# Air Resources Board

September 26, 2008

# 08-04a

**HUSKY MODEL 5885 PRESSURE/VACUUM VENT VALVE IS THE REQUIRED  
REPLACEMENT PART FOR PHASE I ENHANCED VAPOR RECOVERY (EVR)  
SYSTEMS ON OCTOBER 1, 2008**

**Complying Husky 5885 P/V Vent Valve**

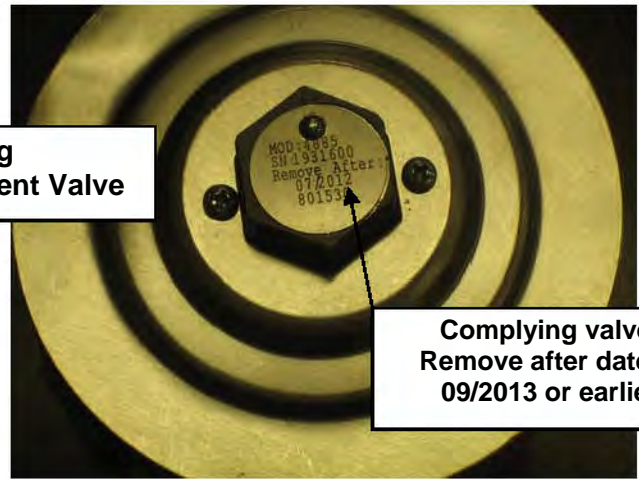
valve. The enclosure shows the approved Husky Model 5885 P/V vent valve, two versions of the Husky Model 4885 P/V vent valve, and the OPW Model 623 P/V vent valve. The approved Husky Model 5885 valve has two yellow labels with black letters. One label provides the performance specifications and the other label has the words, **EVR Approved**. Any Husky Model 4885 or OPW Model 623 P/V vent valve manufactured on or after October 1, 2008, can not be installed in California. The OPW Model 623 P/V vent valve has a production date stamp (month/year) at the top of the valve. The Husky Model 4885 P/V vent valve has a **remove after** date stamp at the top that is five years after the month and year of production. Husky will further identify the 4885 valves that are not approved for sale in California by a green label containing the performance specifications and the statement, **Not approved for use in California**.

**Complying Husky 4885 P/V Vent Valve**

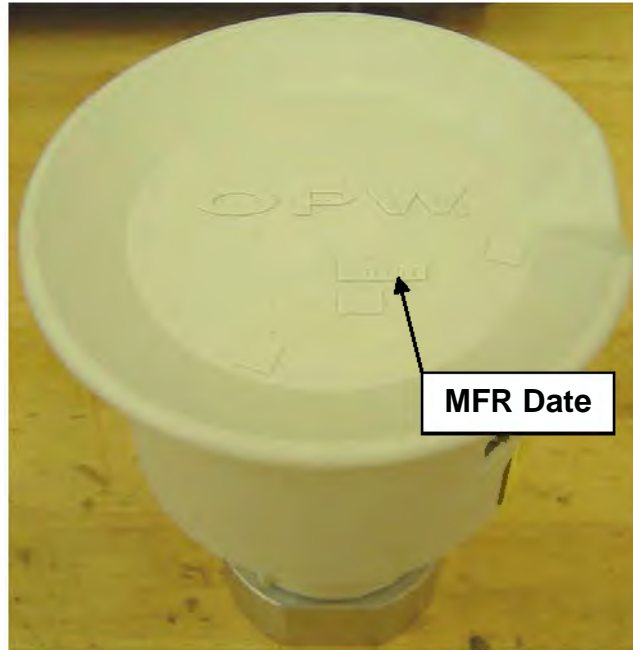
**Complying valve: Remove after date is 09/2013 or earlier**
